# **MINOR CHANGE REPORT**

**MCR62340-1**

## **PILOT PEG STEP INSTALLATION**

Radius change to accommodate Bell 206L3

**02 SOCKET CLAMP**

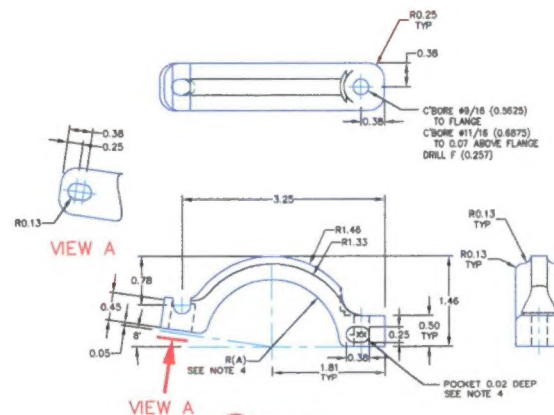
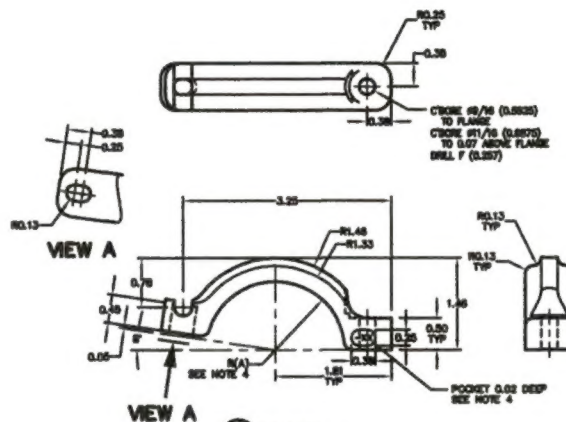
This change is to add a configuration with the inside radius of the socket and clamps increased to 2.28" diameter.

1. New configuration of 62340-02 Socket added with inside radius of 1.14"
2. New configuration of 62340-03 Clamp added, with inside radius of 1.14"
3. New configurations are identified as dash no. -03.

③ CLAMP

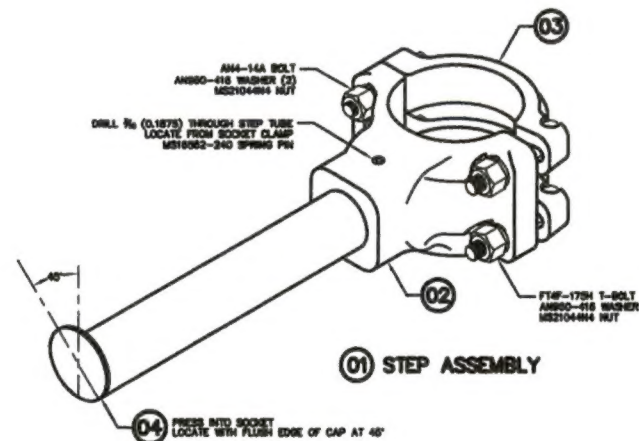
The critical section is the top clamp strap as it is in tension and has the smallest section.

The minimum cross section is at the bottom of the counter bore, and is 0.093" thick at that point.
